Subject: Dresden Nuclear Power Station, Unit 3
Weld Overlay on RWCU Non-Regenerative Heat Exchanger 3-1204AB
Tubeside Inlet Nozzle.
NRC Docket No. 50-249

ComEd Response to NRC's REQUEST FOR ADDITIONAL INFORMATION CONCERNING THE REACTOR WATER CLEANUP SYSTEM HEAT EXCHANGER REPAIR

**COMMONWEALTH EDISON COMPANY
DRESDEN NUCLEAR POWER STATION, UNIT 3
DOCKET NO. 50-249**

Figure 1
Through Wall Indications on 3-1204-AB Inlet Nozzle

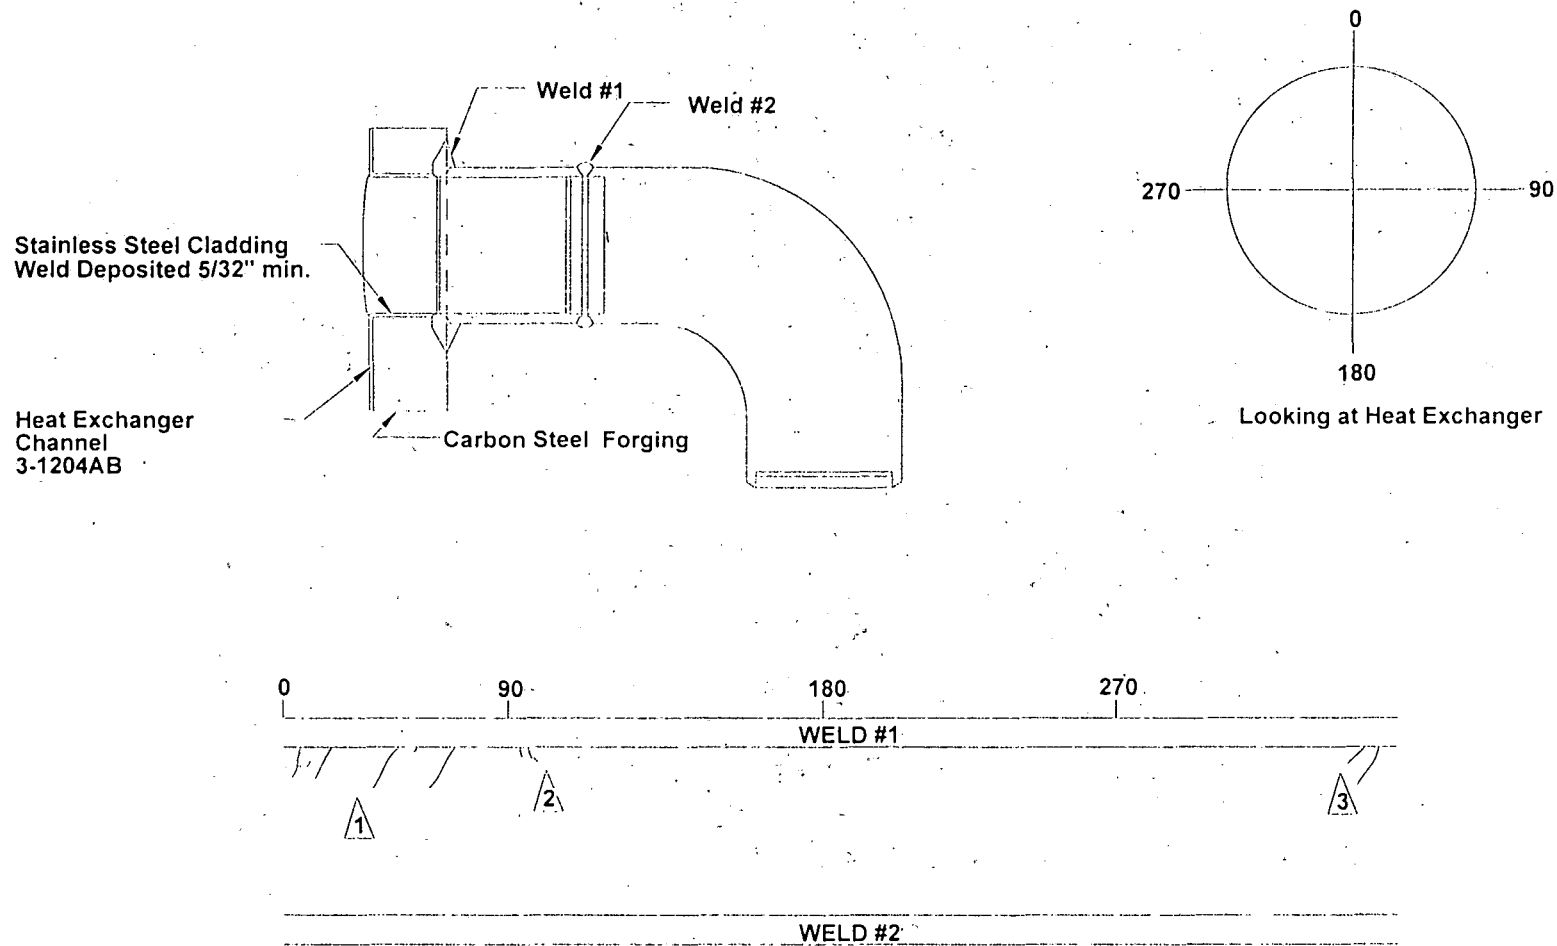
1. Provide a description of the flaw, including the size, location and a sketch of the exact location of the flaw.

Response: The attached Figure No. 1 contains a map and description of the flaws. The two indications closest to 0° in area 1 of this report are believed to be the throughwall flaws. Positive identification of throughwall flaws was not made since the flaws were not excavated.

- ① 5 linear indications ranging in size from 1/8" to 1". Indications extend from the toe of the weld on the pipe side.
- ② 2 linear indications ranging in size from 1/4" to 5/8". Indications extend from the toe of the weld on the pipe side.
- ③ 2 linear indications ranging in size from 3/16" to 3/4". Indications extend from the toe of the weld on the pipe side at approximately 350 degrees.

Figure 2
As Measured Overlay Dimensions

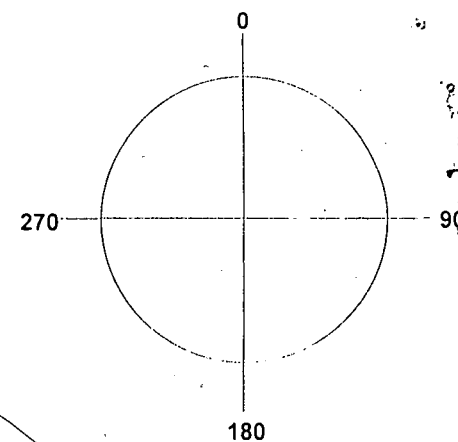
2. Provide the as-measured weld overlay dimensions.

Response: The as-measured weld overlay dimensions are provided in Figure No. 2.

THICKNESS MEASUREMENT AFTER FIRST 2 LAYERS

0	90	180	270
(1)	0.566	0.581	0.561	0.591
(2)	0.521	0.506	0.465	0.495

FINAL THICKNESS MEASUREMENT

0	90	180	270
(1)	0.891	0.966	0.986	0.916
(2)	0.816	0.901	0.896	0.891
